Program Bulletin

SB-10056214-9273

CUSTOMER SATISFACTION PROGRAM

SUBJECT: Front Strut - Noise

Figure 1

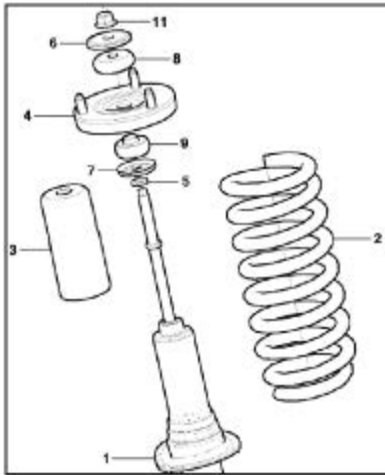
4. Before removing the top mount bracket (refer figure 1, item 4), place alignment marks on the top mount bracket and spring using the outboard mounting bolt on the strut top bracket as a reference. Mark the bottom of the spring to shock absorber as well. These marks should all be aligned as shown in figure 2 and 3.

6. Refer to figure 1 - the lower bush (9) will be replaced as well as the spring seat insulator (not shown in figure 1). In addition, inspect the top mount bracket (4), cup washer (7), upper bush (8), and shocker absorber rod (1) for damage. Follow these guidelines to determine if these parts should be replaced:

Figure 5 — Check if Silver Washer Has Worn Through

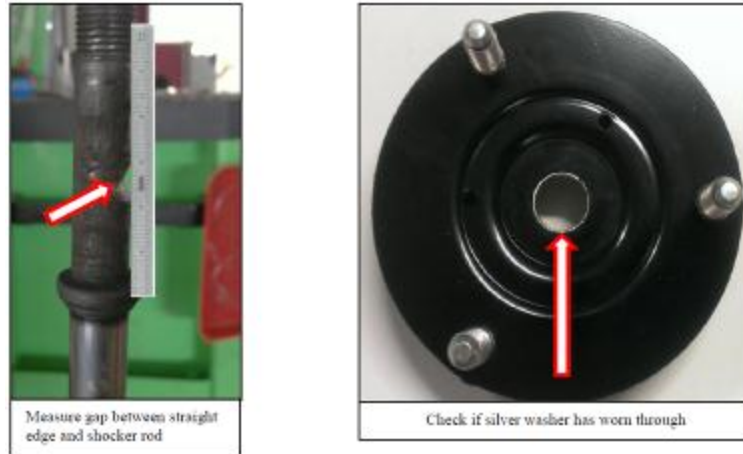
- Inspect the steel washer (silver) that is pressed into the centre of the top mount bracket. If the washer has worn through to the black steel mount bracket, then replace the top mount bracket, refer figure 5.
- Inspect the upper bush (8), if the bush is out of shape or is damaged, replace the bush. In most cases it is expected that the upper bush can be reused. Do not replace it unless necessary.
- Inspect the cup washer (7) for distortion or other damage. Replace only if required.
